Addendum No: 7
Date: February 9, 2024
Owner: Northern Health
Stantec # 144320228

Client/Project
Northern Health Authority
UHNBC (University Hospital of Northern BC) -
NAPRA Pharmacy Renovation
1475 Edmonton St, Prince George, BC V2M 1S2

Project No.	Scale
144320228	As indicated
Revision	Drawing No.
B	E100

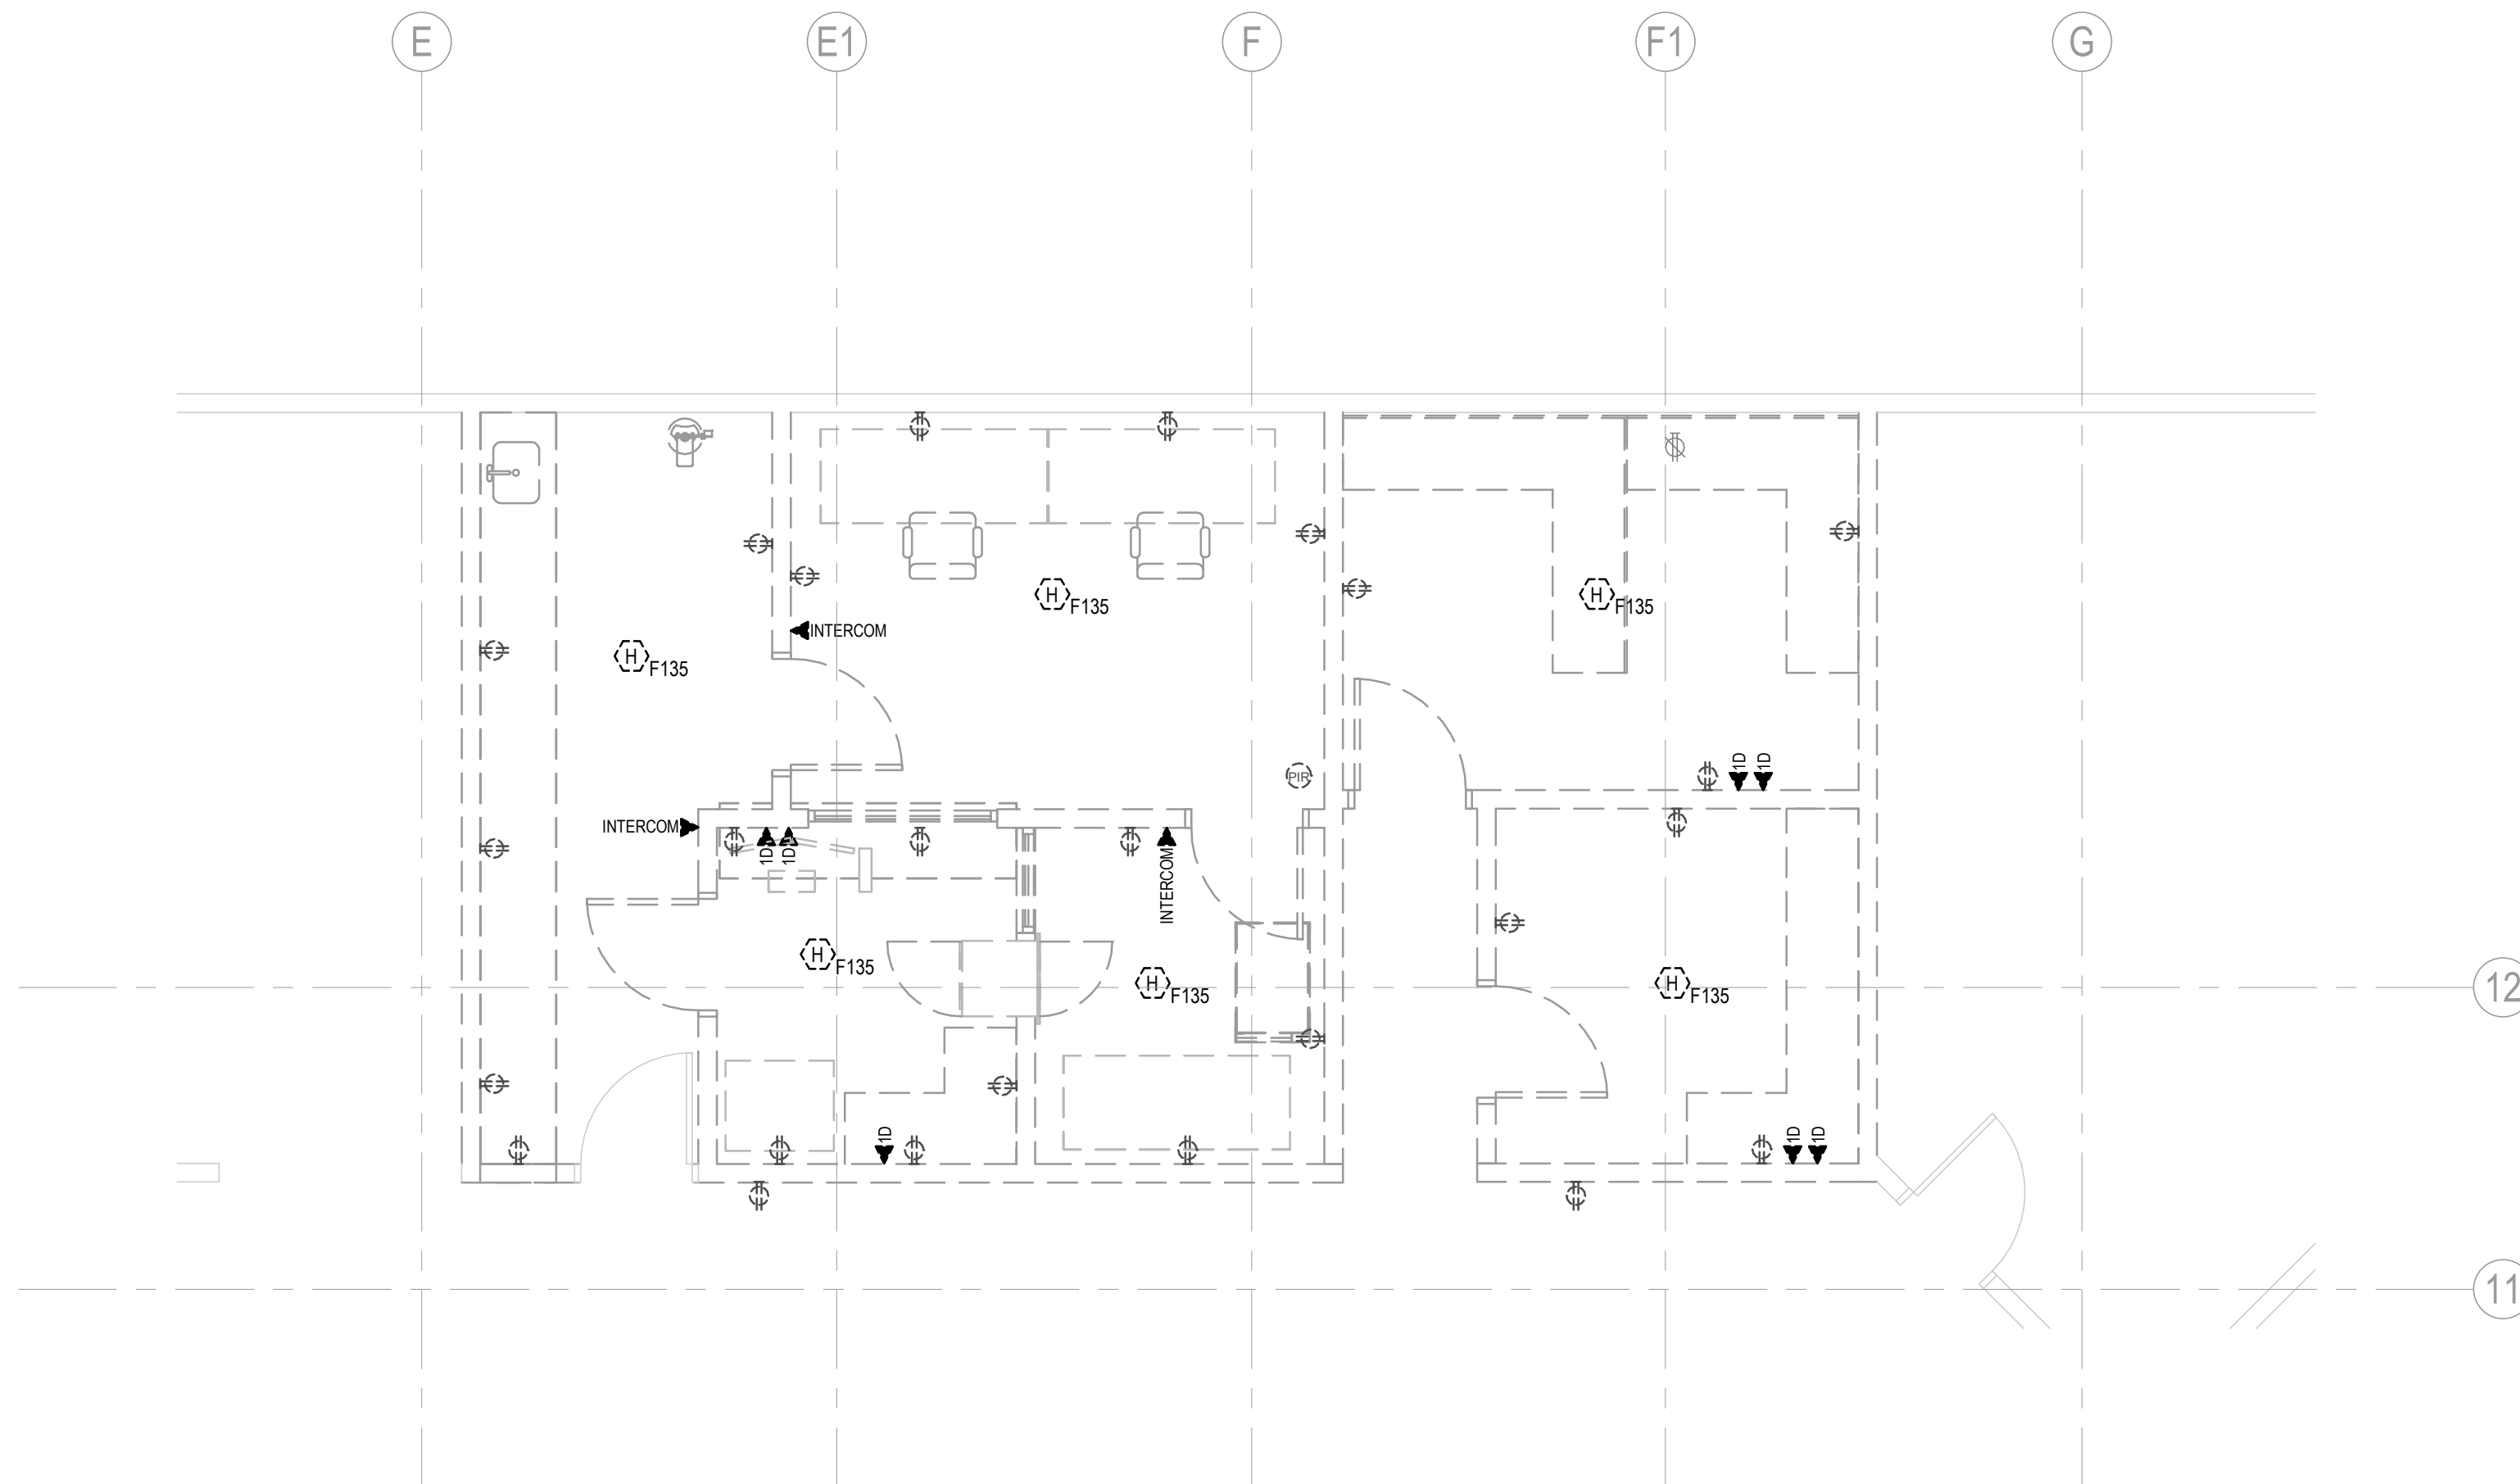
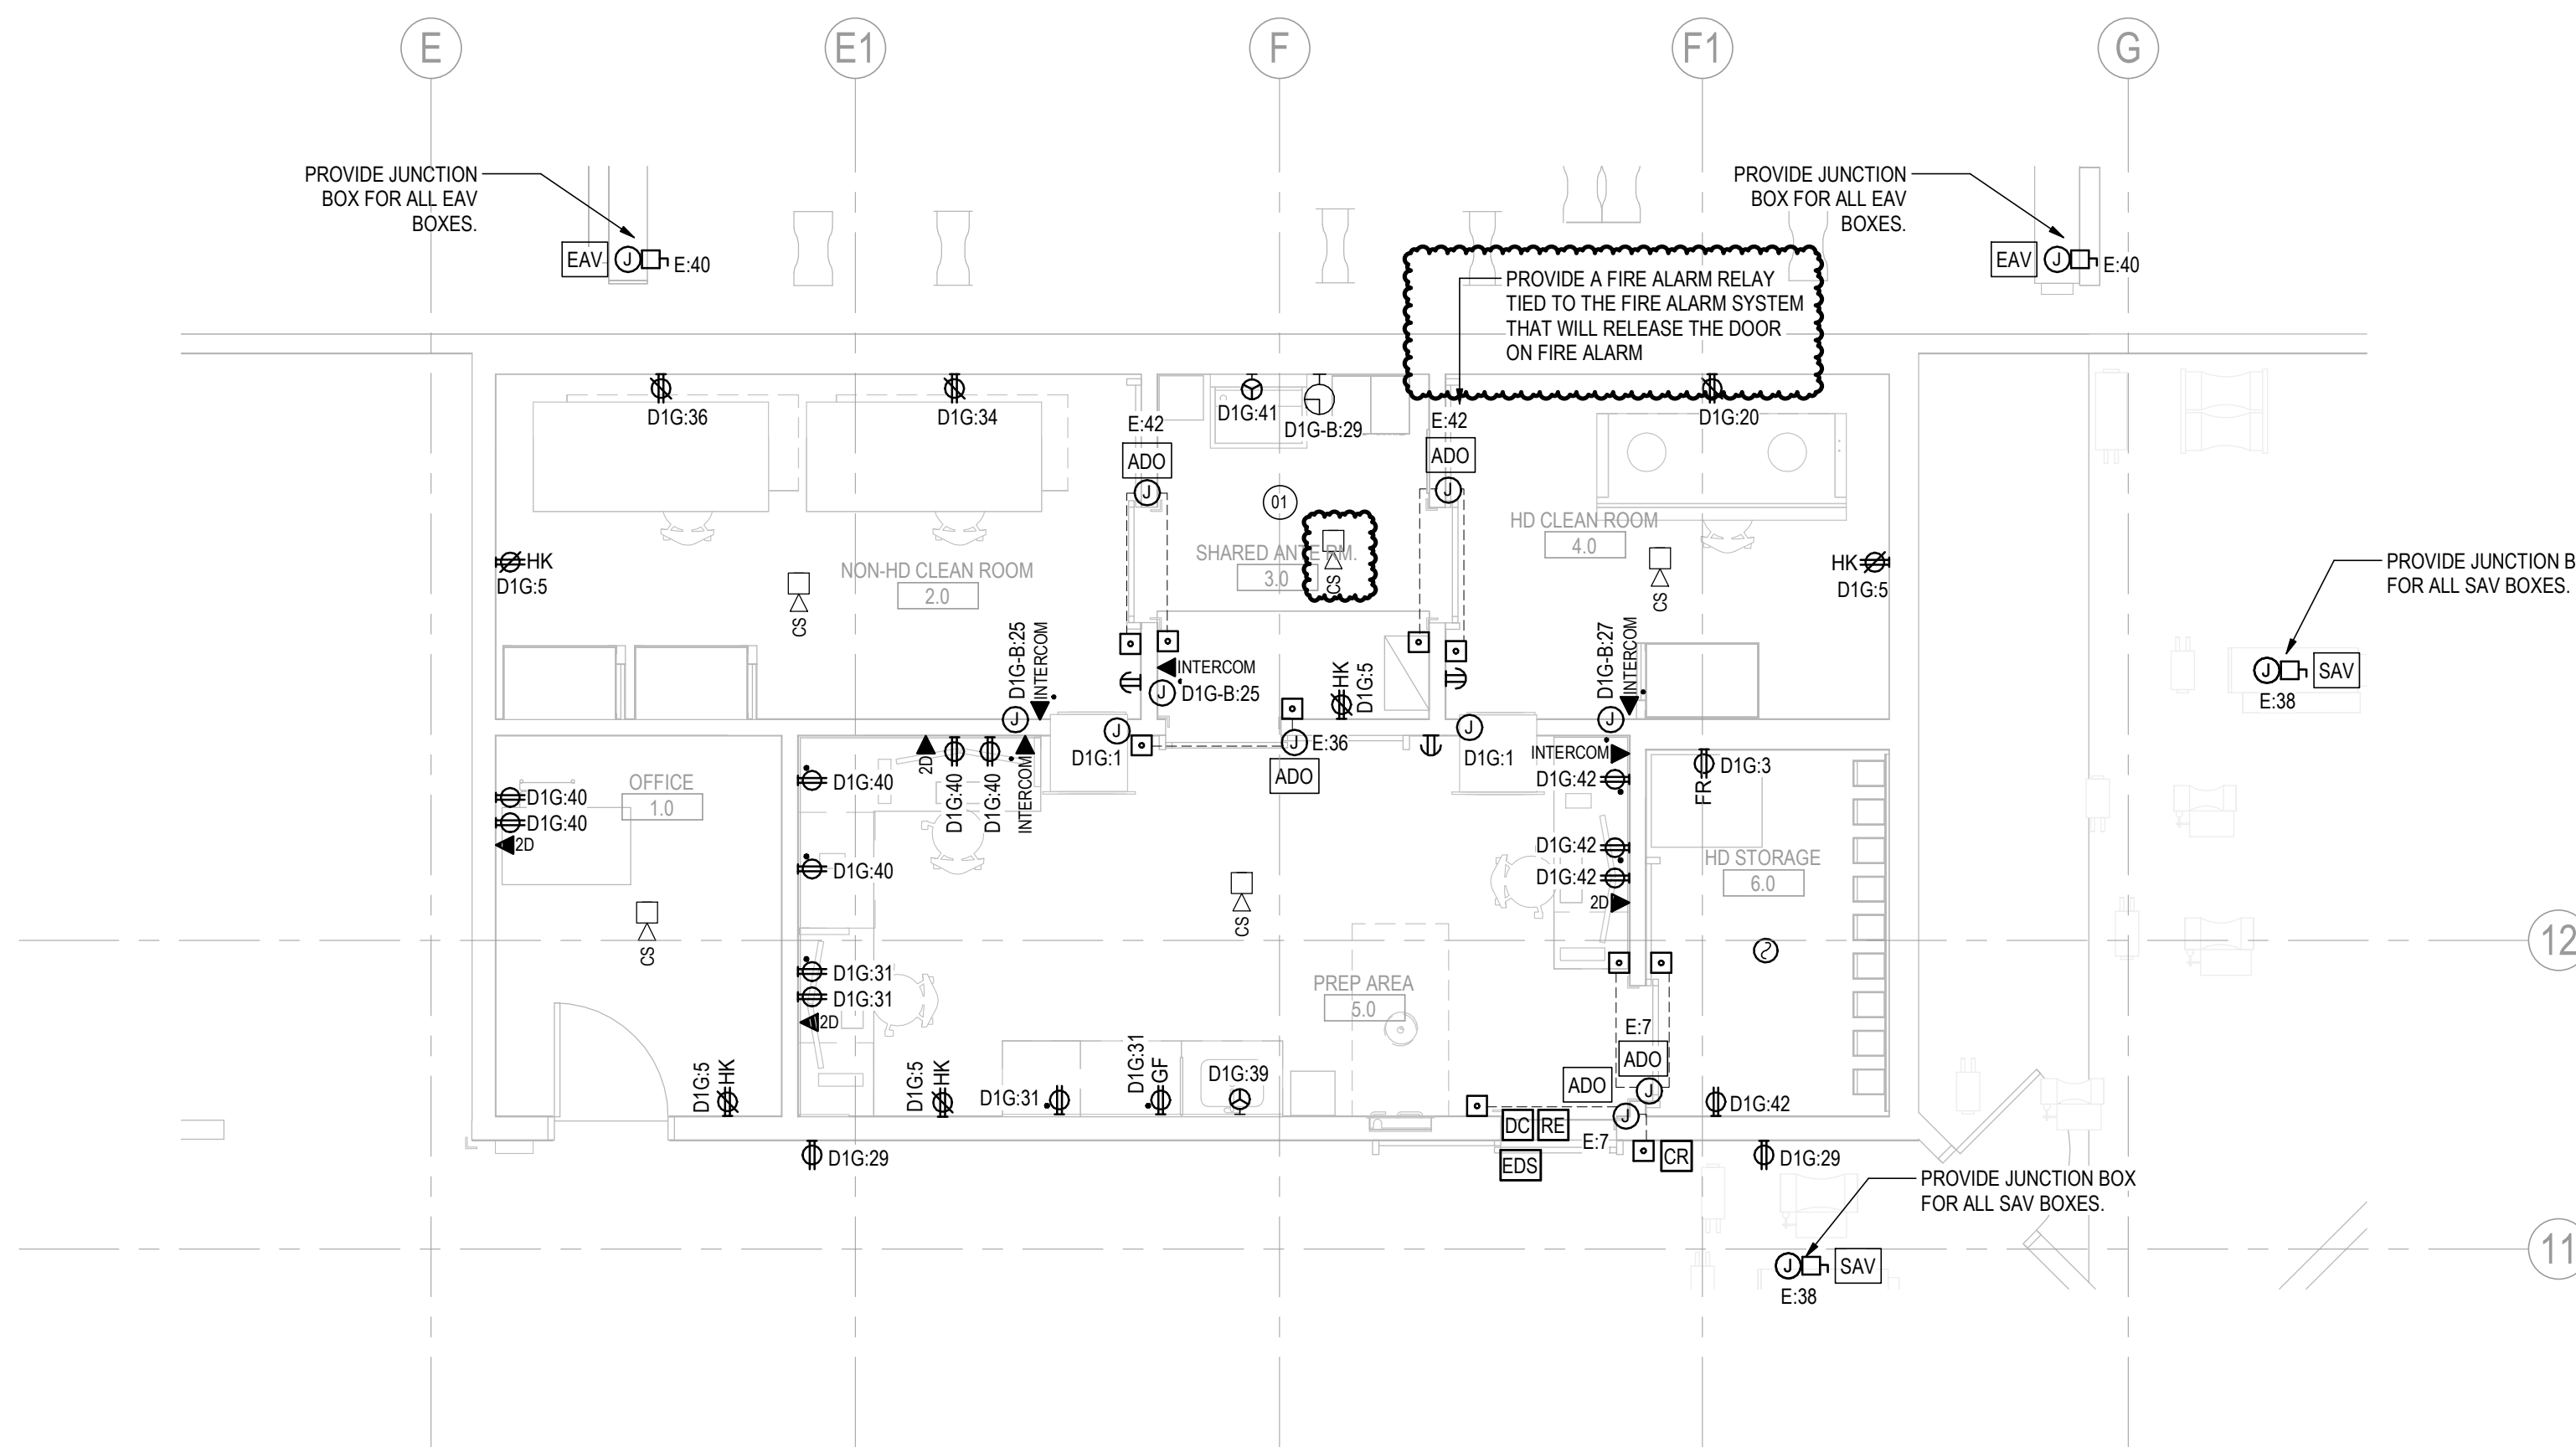
E100 – add a fire alarm speaker in the Shared Ante Rm. 3.0. Add a fire alarm relay tied to the fire alarm system that will release the door on fire alarm. Add this to the door between the HD Clean Room 4.0 and the Shared Ante Space 3.0. All new receptacles are to be Hubbell Hospital Grade Snap Type Receptacles (Illuminated).

Drawing No.
E101

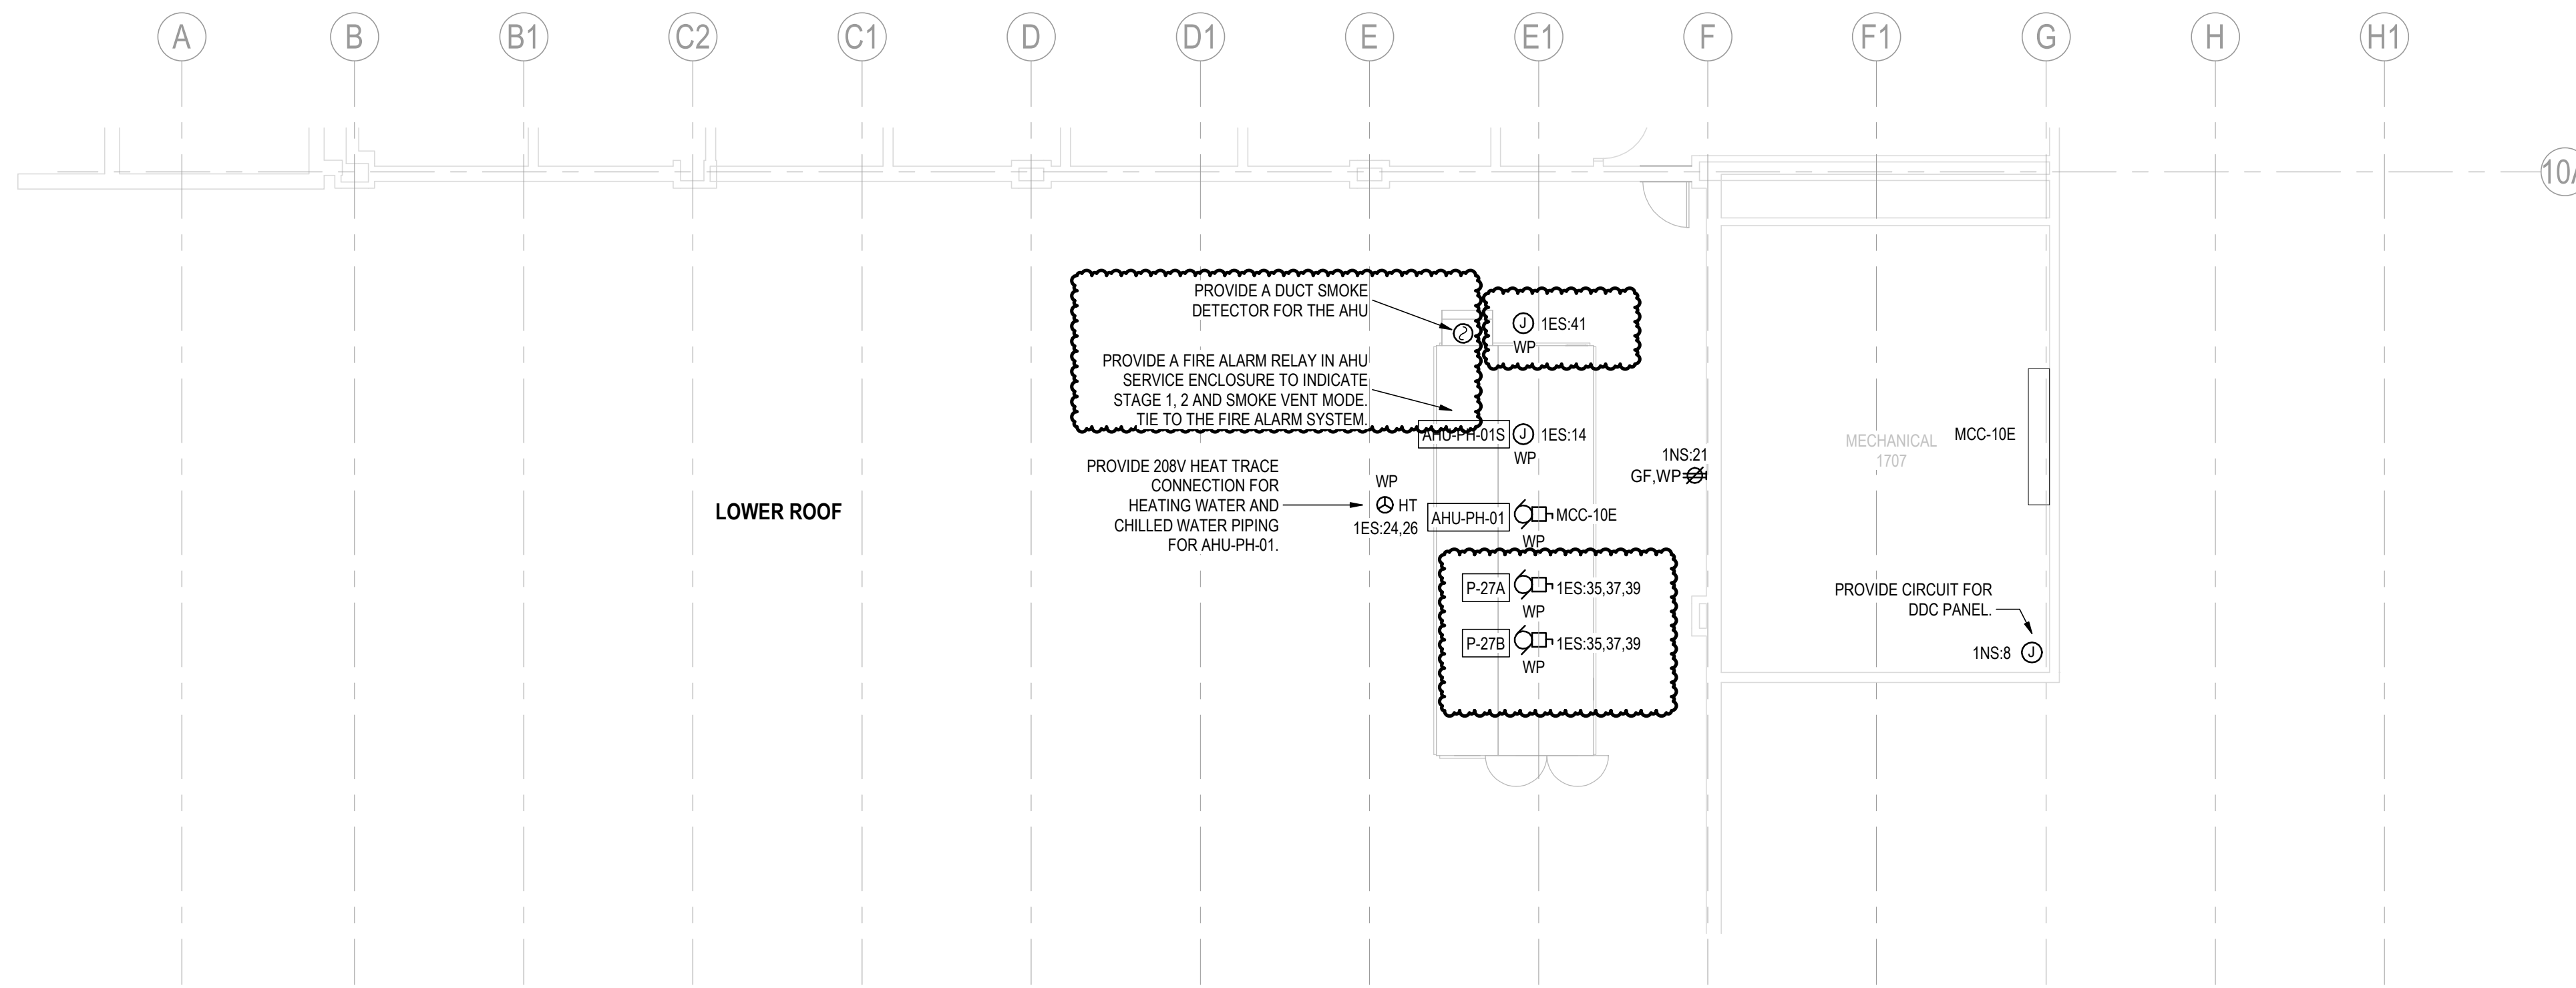
E101 – add power connections for two new pumps, located in the AHU. Provide a 20A 3P breaker on panel 1ES. Allow for the re-arrangement of breakers in the panel to create enough space for the 3P breaker. Remove and hand over to the client any breakers labeled as “Spare”. Provide and install a magnetic On/OFF starter for each pump. The starter is a Nema 3R combination starter, with an integral circuit breaker.

Provide a junction box for control power on the roof. Provide the wiring and conduit to Panel 1ES. Provide a new 15A 1P breaker.

Provide a duct smoke detector for the AHU. Tie to the fire alarm system.

Provide a fire alarm relay in AHU service enclosure to indicate stage 1, 2 and smoke vent mode. Tie to the fire alarm system.
